CSP-06003
DSP-17023

Application	General Data	
Project Name: Addison Row, Phase 1 Expedited Transit-Oriented Development Project Location: On the north side of Addison Road, approximately 35 feet north of its intersection with North Englewood Drive. Applicant/Address: Jemals Fairfield Farms, LLC 702 H Street, NW, Suite 400 Washington, DC 20001	Planning Board Hearing Date:	07/12/18
	Staff Report Date:	07/10/18
	Date Accepted:	05/21/18
	Planning Board Action Limit:	07/21/18
	Plan Acreage:	34.59
	Zone:	M-X-T
	Dwelling Units:	N/A
	Gross Floor Area:	N/A
	Planning Area:	72
	Council District:	05
	Election District	18
	Municipality:	N/A
200-Scale Base Map:	203NE05

STAFF REPORT

SUBJECT: Conceptual Site Plan Amendment CSP-06003
Detailed Site Plan DSP-17023
Type 2 Tree Conservation Plan TCP2-007-2016-01
Addison Row, Phase 1
Expedited Transit-Oriented Development Project

ELEVATIONS

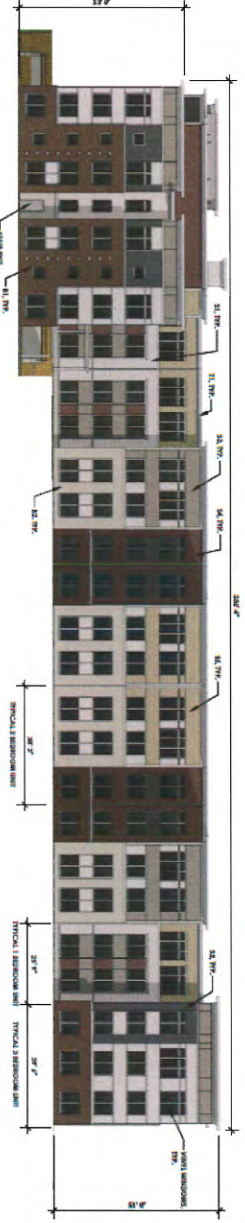
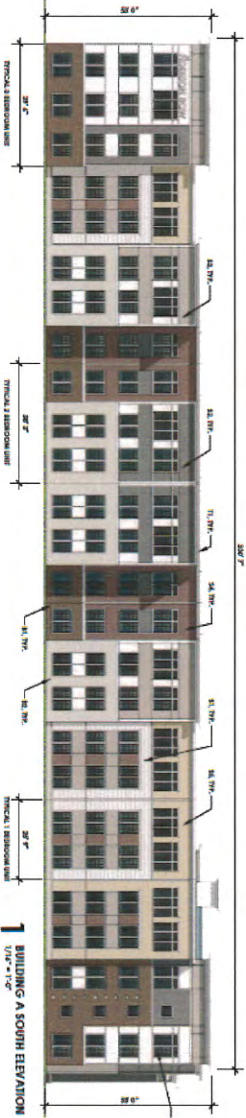
The southern elevations along Addison Road feature vertical divisions of the façades for every two to three bays, creating comfortable visual blocks. A variety of contrasting color tones have been used on the elevations to create more diversity than uniformity. The Urban Design Section suggests that the dark colored brick be applied throughout the first floor of the building to form a consistent base section, to tie the visual blocks along Addison Road. A condition has been included in the Recommendation section of this report requiring the applicant to revise the southern elevations, to be reviewed and approved by the Urban Design Section as the designee of the Planning Board, prior to certification of this DSP.

The proposed development includes architectural elevations that have been reviewed by the Urban Design Section. The applicant has been working to enhance the architectural elevations that are highly-visible from public roadways. A condition has been included in the Recommendation section requiring the applicant to increase the use of brick on those elevations fronting on Addison Road, to provide a more consistent first floor and a high-quality finish.

**TYPE I
TREE CONSERVATION
PLAN SHEET**

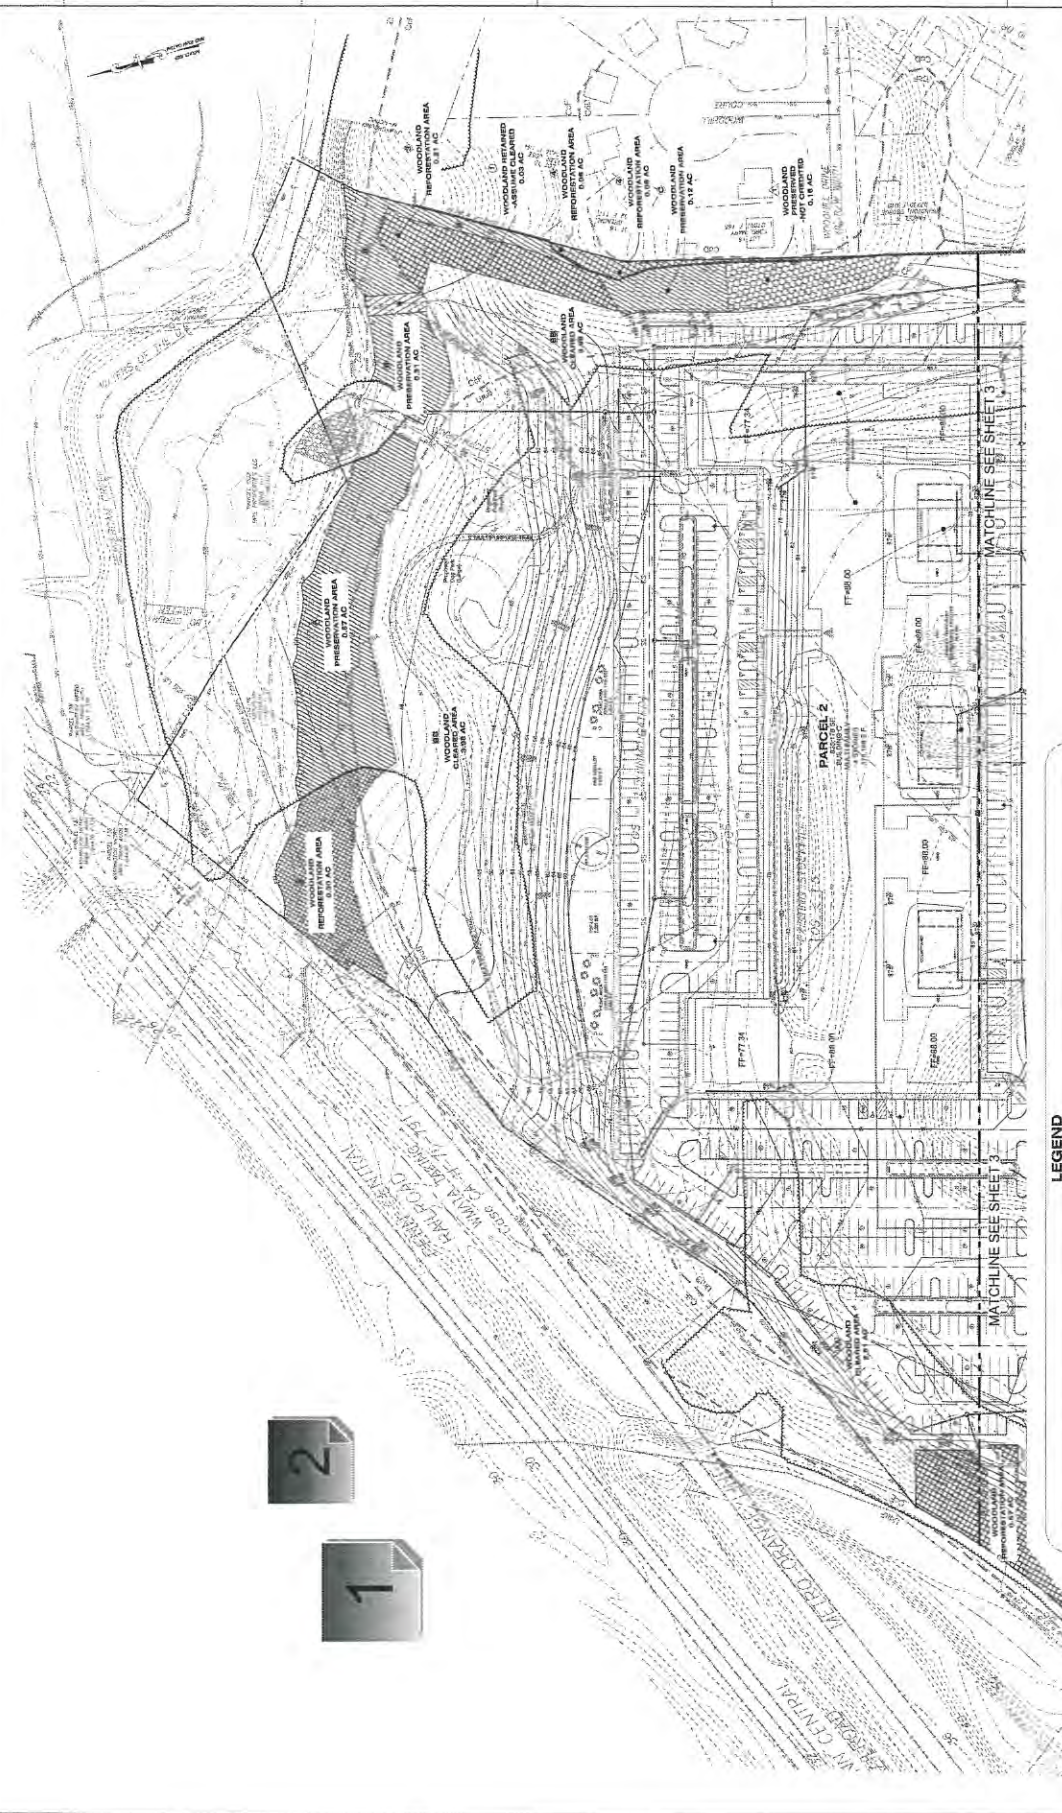
1. Revise the TCP2 approval block to add the Development Review Division number (DSP-17023) and the reason for review (Phase I) information.
2. Label the 65dBA Ldn noise contour on Sheet 3 and 4.

1. Prior to signature approval of the detail site plan, the TCP2 shall be revised as follows:
 - a. Revise the TCP2 approval block to add the Development Review Division number (DSP-17023) and reason for review (Phase I) information.
 - b. Label the 65dBA Ldn noise contour on Sheet 3 and 4.
2. No woodland conservation shall be shown on land to be dedicated to the Department of Parks and Recreation (DPR) unless written consent from DPR is provided.
3. Development of this subdivision shall be in conformance with an approved Type 1 Tree Conservation Plan (TCP1-041-07-01). The following note shall be placed on the Final Plat of Subdivision:
